ADDENDUM #1

Bid #09-11-12-01 "Partial Window/Door Replacement & Abatement at the Danbury High School"

ADDENDUM NO. 1

PROJECT NAME: PARTIAL WINDOW/DOOR REPLACEMENT AND ABATEMENT
AT THE: DANBURY HIGH SCHOOL

DRAWING TITLE:
DETAILS - CAPPING FRAME @
BASE AND MULLION
(REF. DWG. A-752)

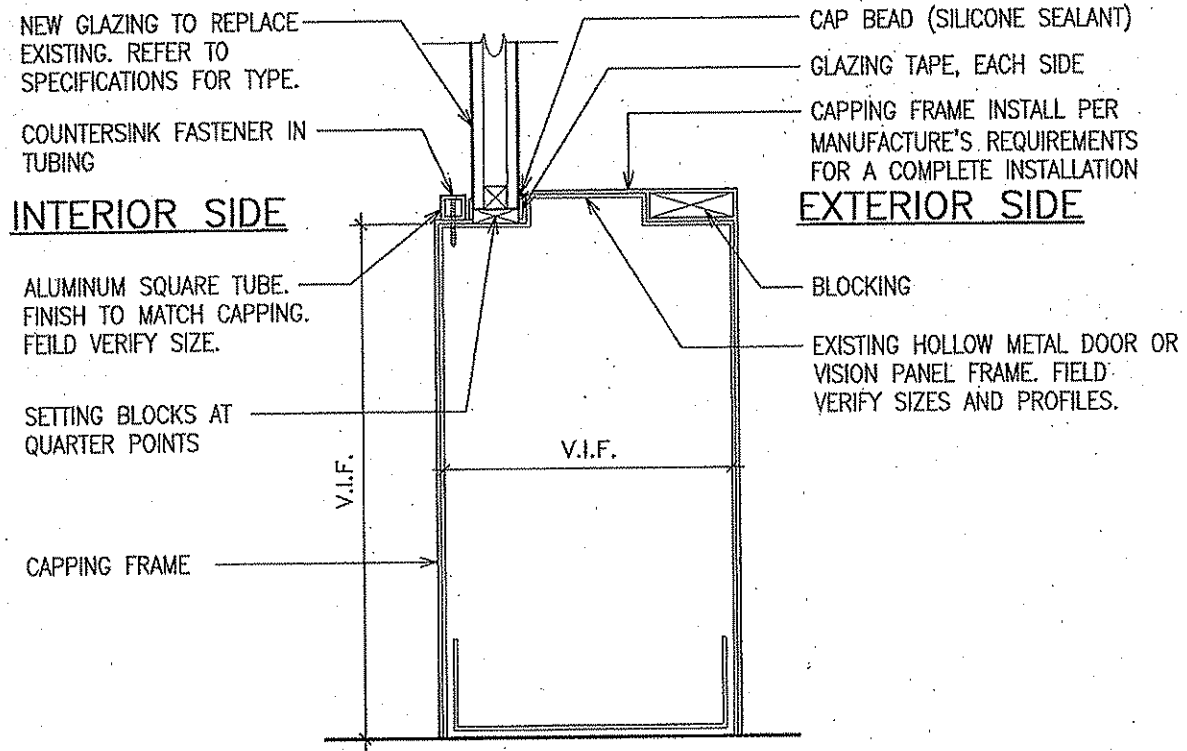
DRAWING A-752 – FRAME DETAILS:

Refer to SKB-1 for additional capping details.

DETAIL - CAPPING FRAME @ MULLION (VERTICAL AND HORIZONTAL)

DETAIL - CAPPING FRAME @ BASE

DRAWING TITLE:
SITE PLAN AND SEQUENCING
(REF. DWG. S-1)

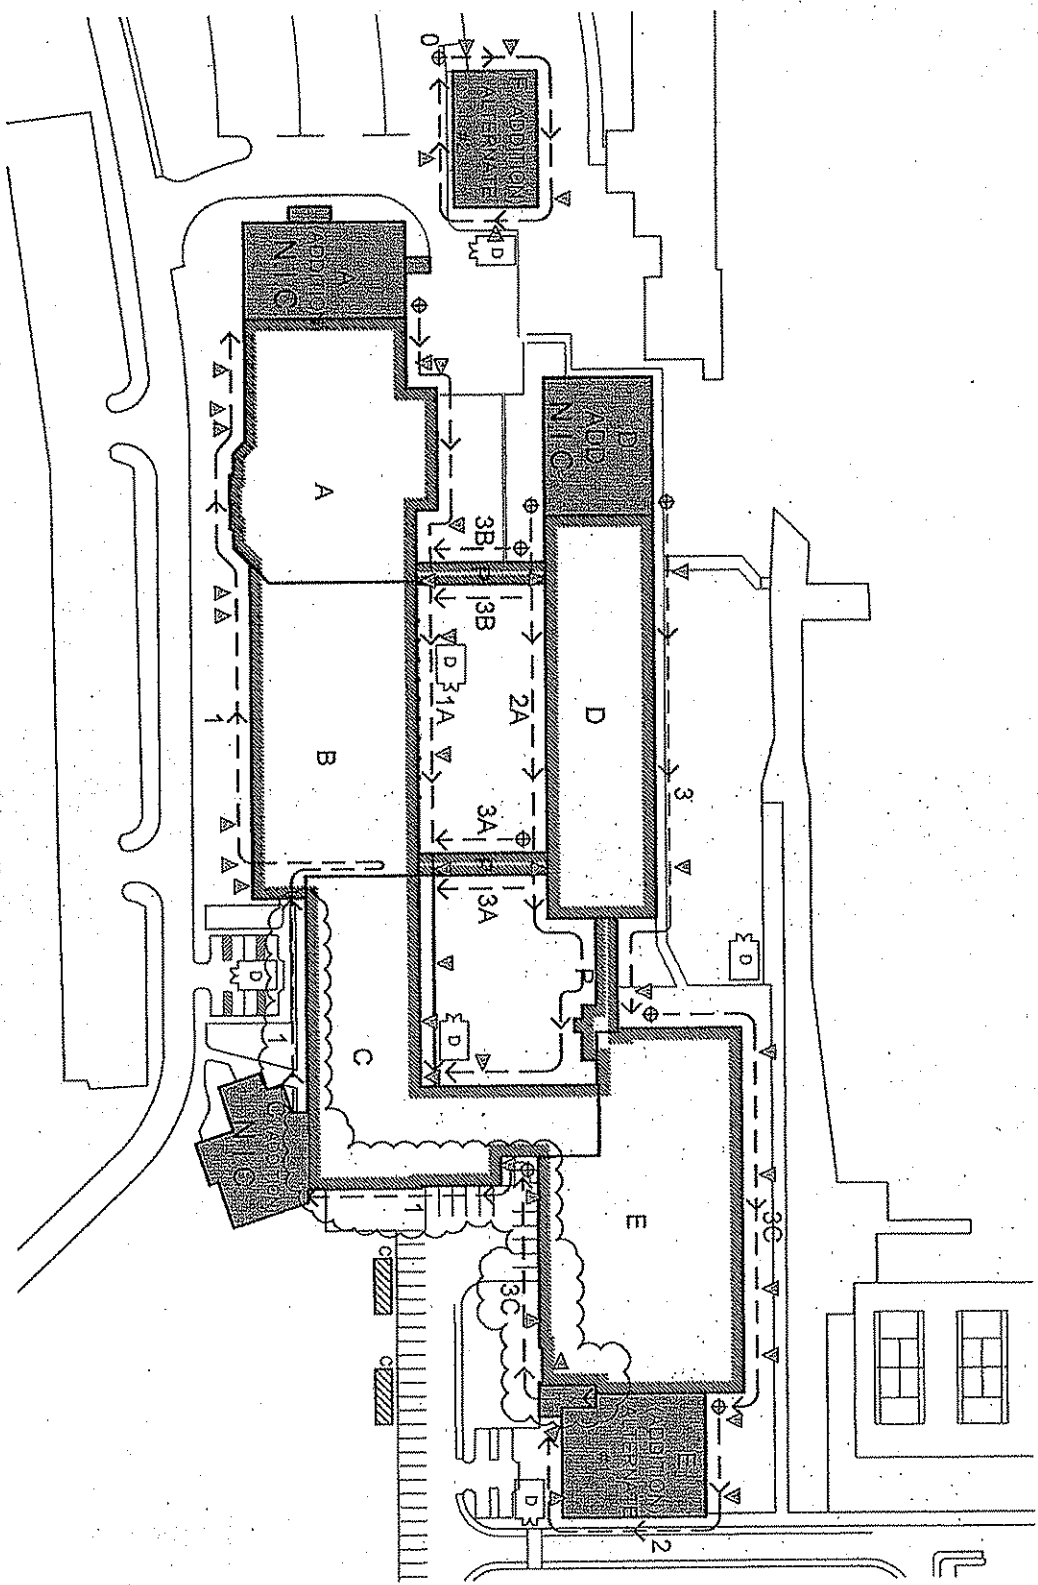
DRAWING S-1:

Refer to SKB-2 for revisions to Area 1 and Area 3C.
